Request from: Connecticut Siting Council

**PSEG Power Connecticut LLC
Petition No. 1218**

**Data Request CSC-08
Dated: 04/28/2016
CSC-08
Page 1 of 1**

PLANT LAYOUT
UNIT 5 COMBINED CYCLE PROJECT
SINGER SUBSTATION

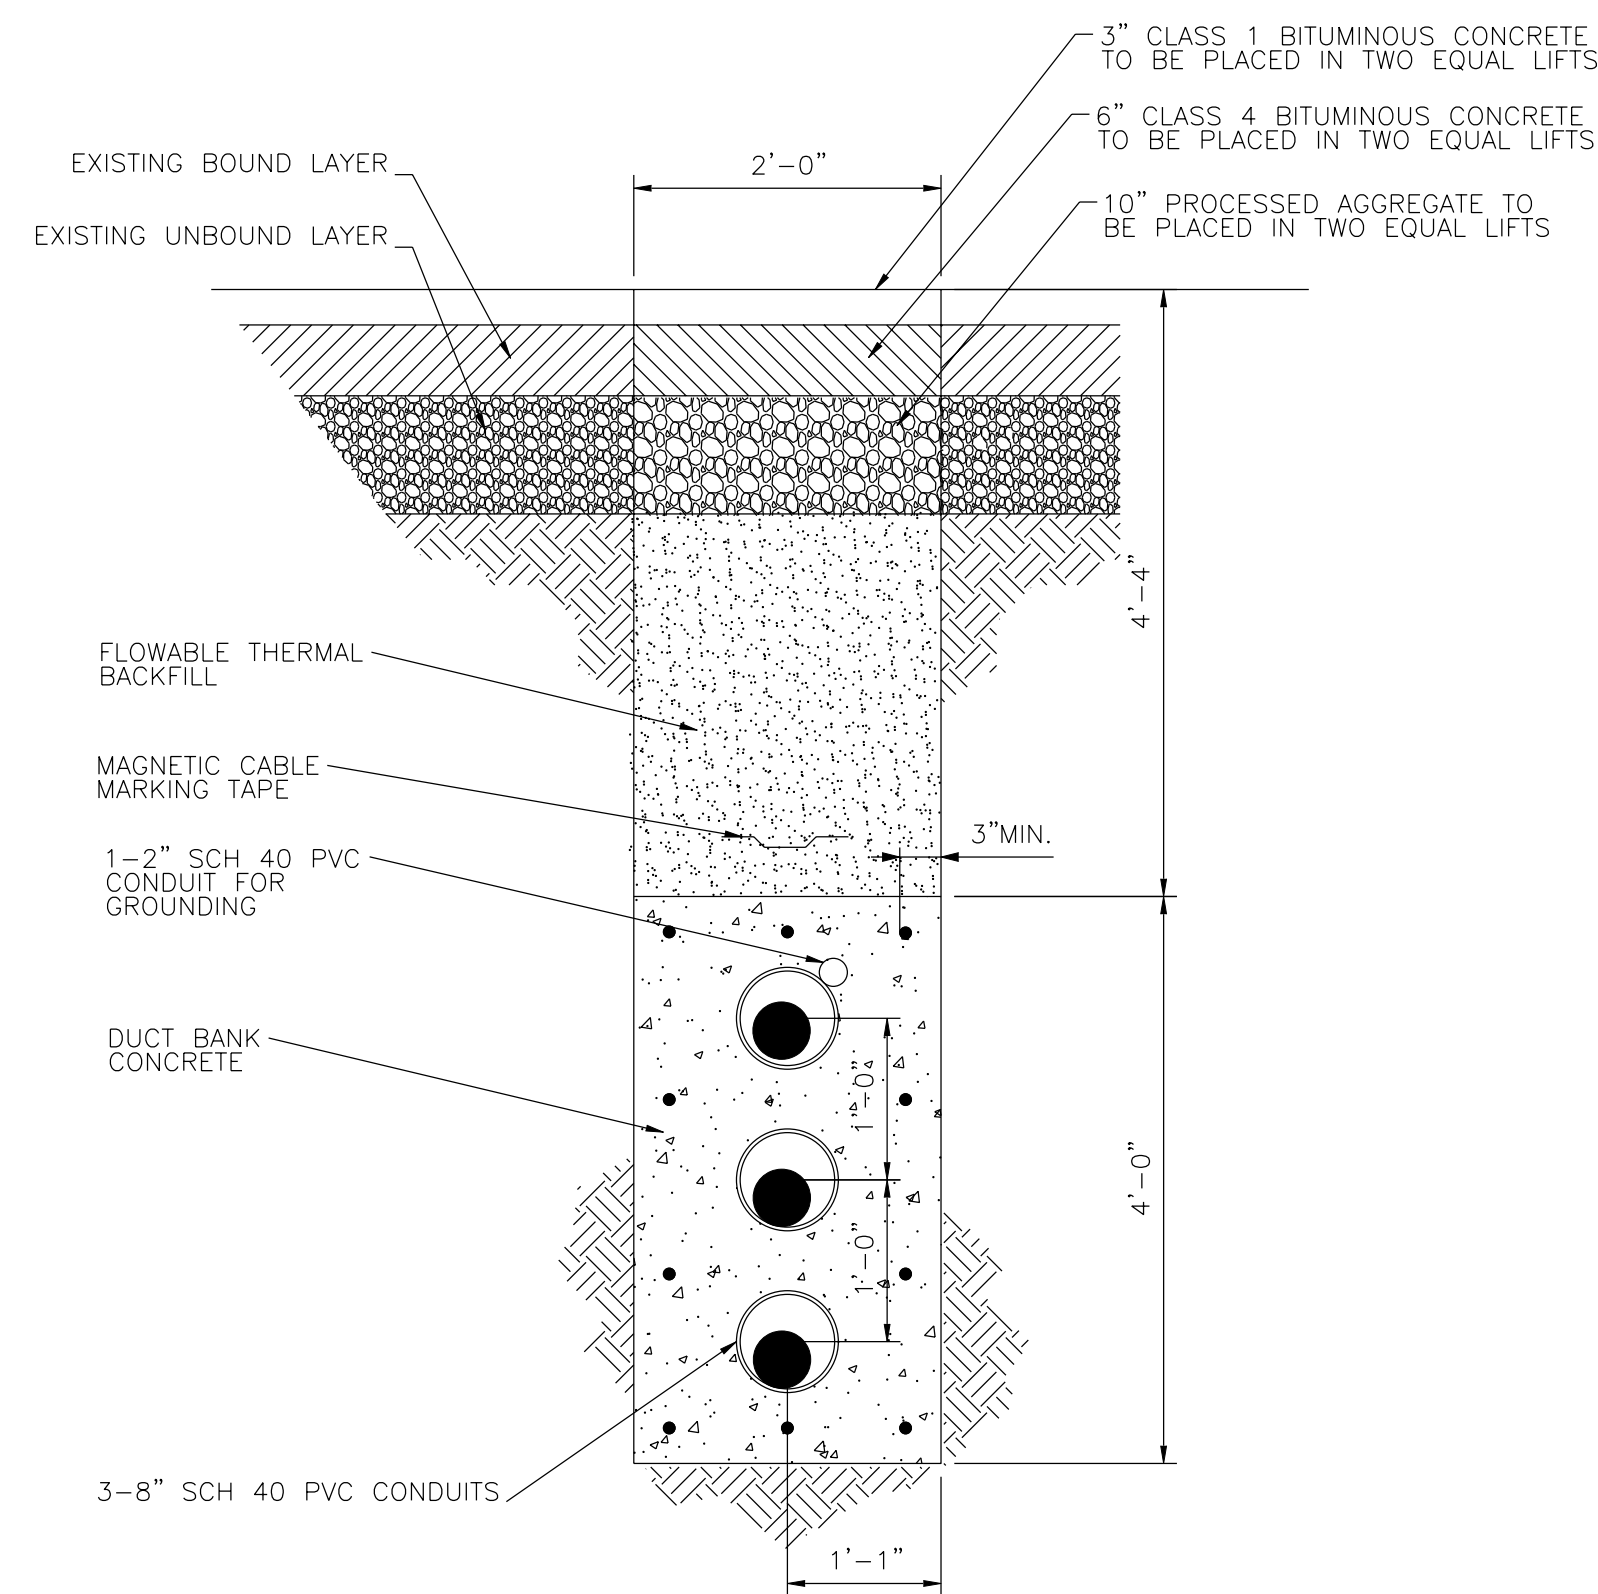
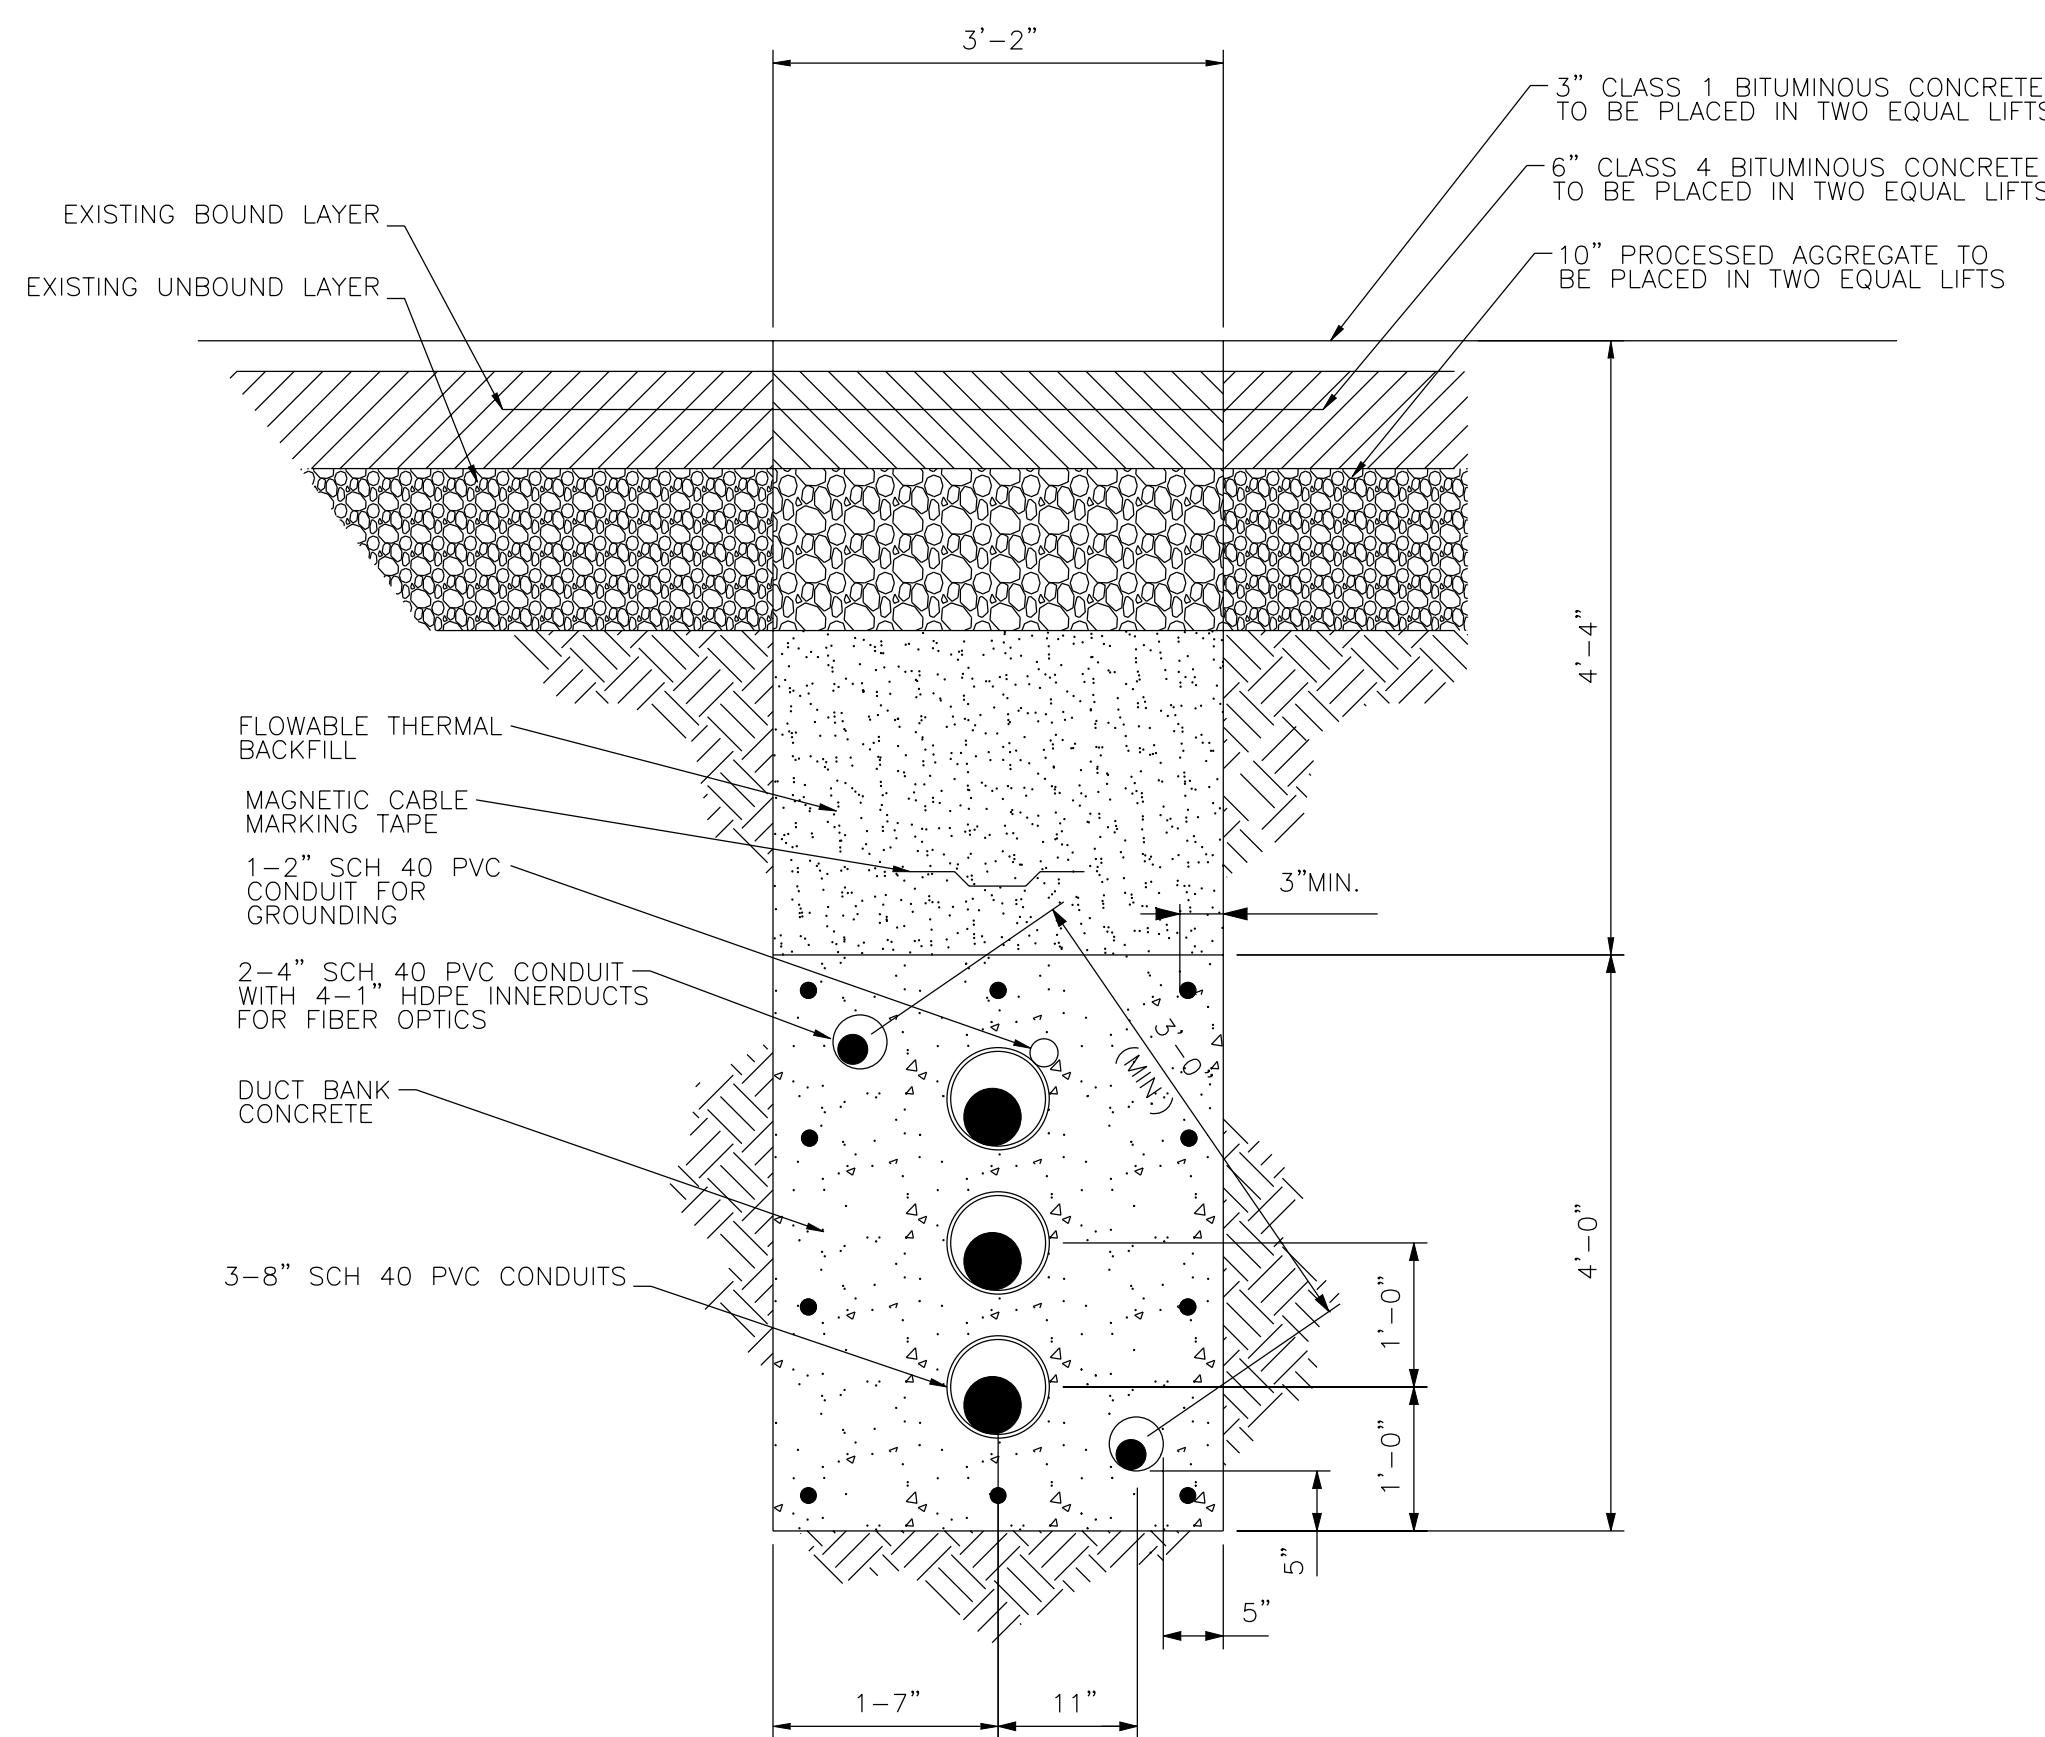
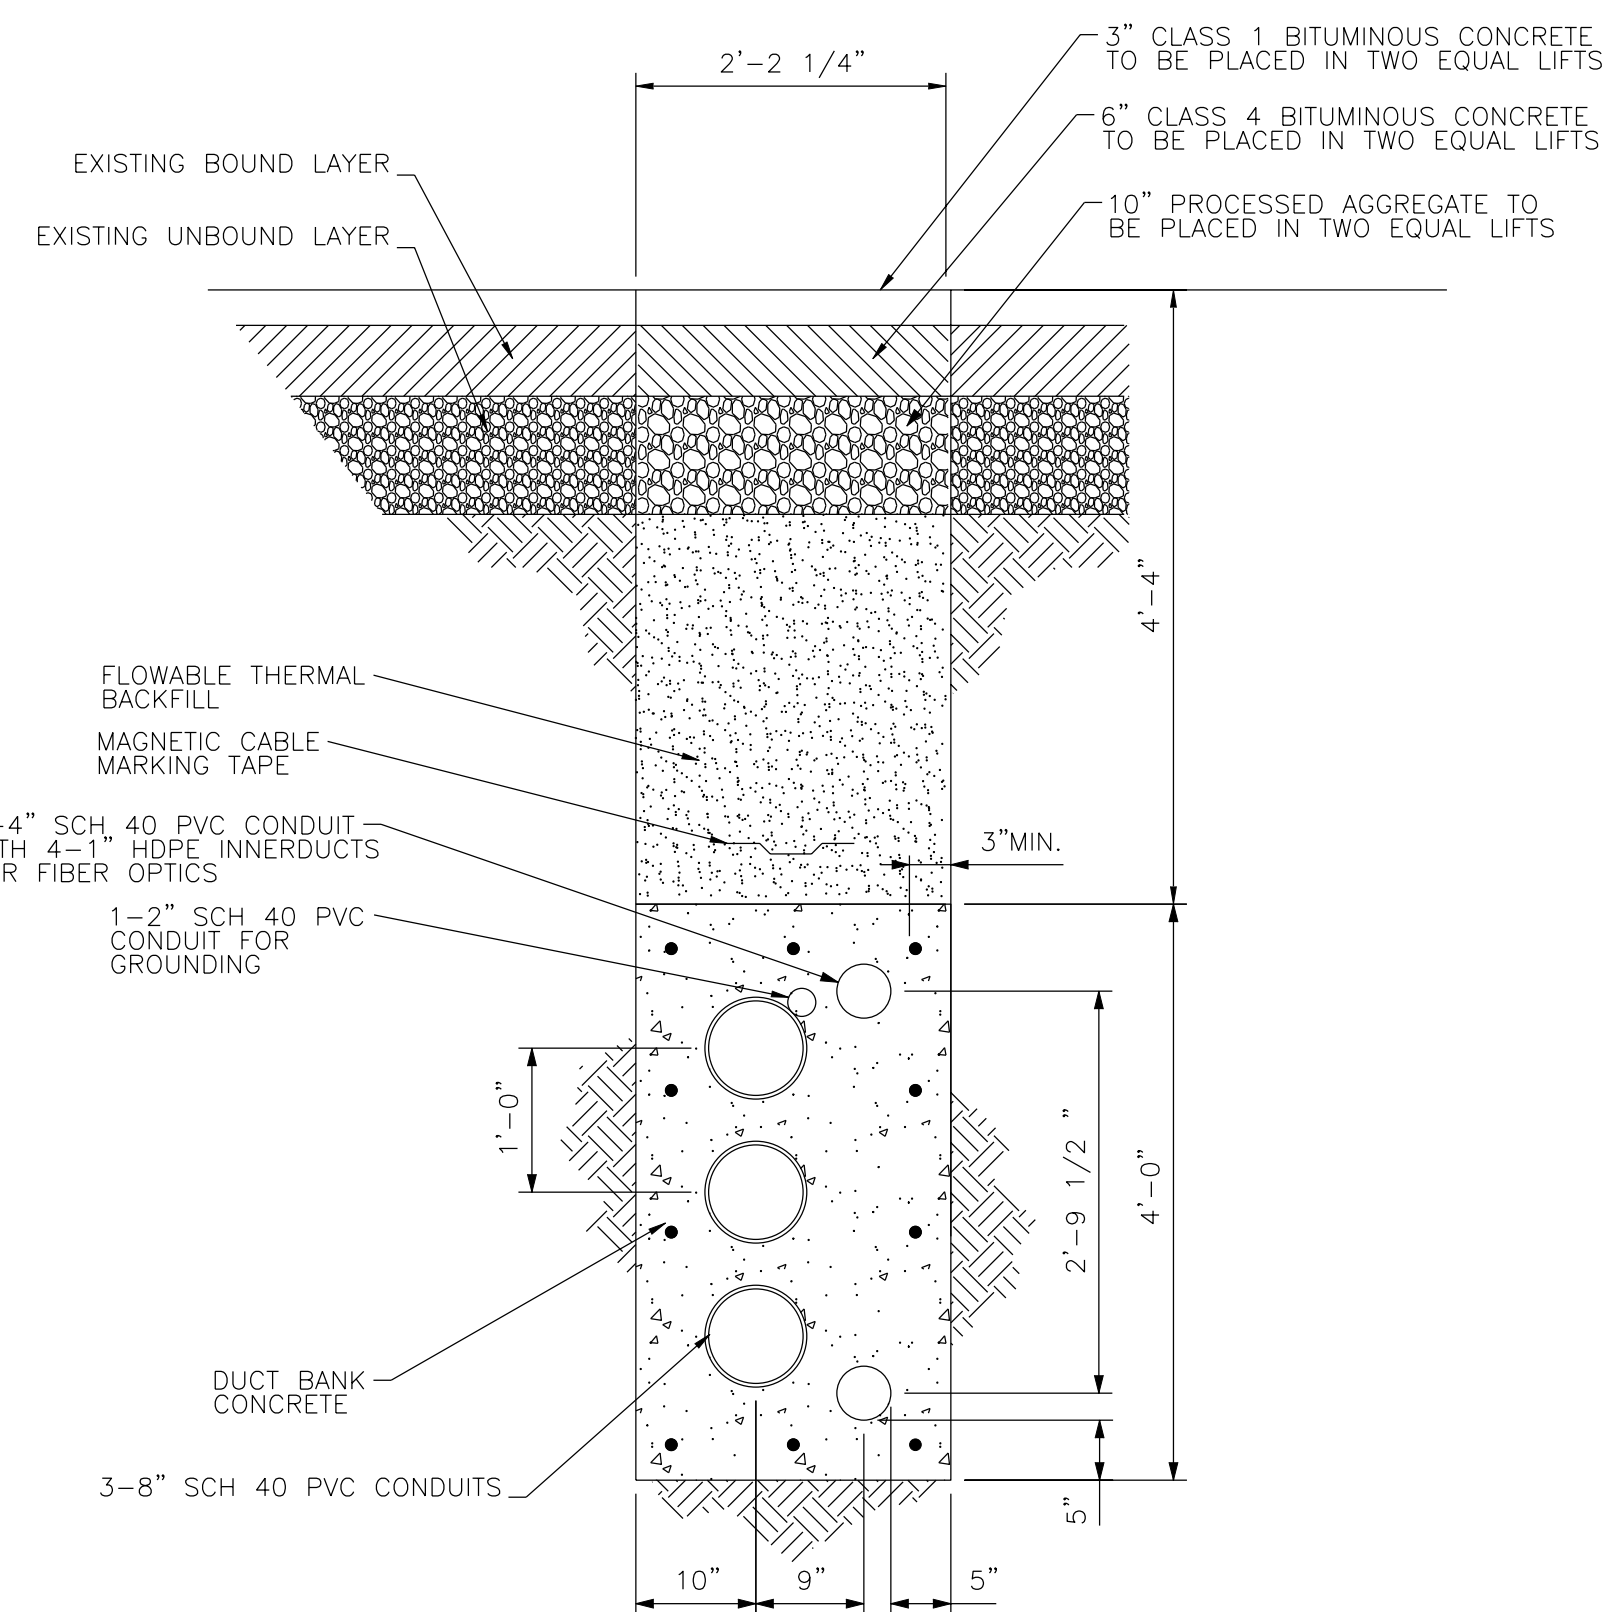
CSC-17. If the proposed project is approved, would PSEG (and/or The United Illuminating Company) file a separate petition for the 345kV underground electrical transmission cable and interconnection portion of the project or is this part of the instant Petition?

directed by underground cable to the 345 kV GIS collector bus owned by the Interconnection Customer. Subsequently, a single radial, 345 kV 3000MCM XLPE underground transmission cable will be constructed, owned and operated by the Interconnection Customer. This underground transmission cable will run from the Large Generating Facility to and in Henry Street, a public street in Bridgeport, Connecticut, to the Interconnecting Transmission Owner's Singer 345 kV substation. The Interconnecting Transmission Owner has consented to the Interconnection Customer constructing, owning and operating the single radial, 345 kV 3000MCM XLPE underground transmission cable circuit in Henry Street. The Interconnection Customer's underground transmission cable will enter the Interconnecting Transmission Owner's facility and terminate at the GIS with a high voltage cable termination. The transmission cable connection can be isolated and grounded from both ends when needed. The Interconnection Customer's 345 kV substation will use a radial arrangement with the main bus rated for 2000A, and will consist of three circuit breaker bays. Each breaker bay will have a manual disconnect switch for a visible safety isolation break from the substation main bus. A three-phase GSU is required for each of the two generators comprising the Large Generating Facility to convert from the generators' output voltage to the grid 345 kV level. The transformers are sized to carry the full capacity rating of the Large Generating Facility. A circuit breaker and disconnect switch are provided for each turbine/generator to isolate each one from its respective GSU. Isolated-Phase buses rated at 25kV and 18kV are provided to connect the unit outputs to their respective GSUs. The attached Exhibit 17-B shows the specifics of the layout and interconnection.
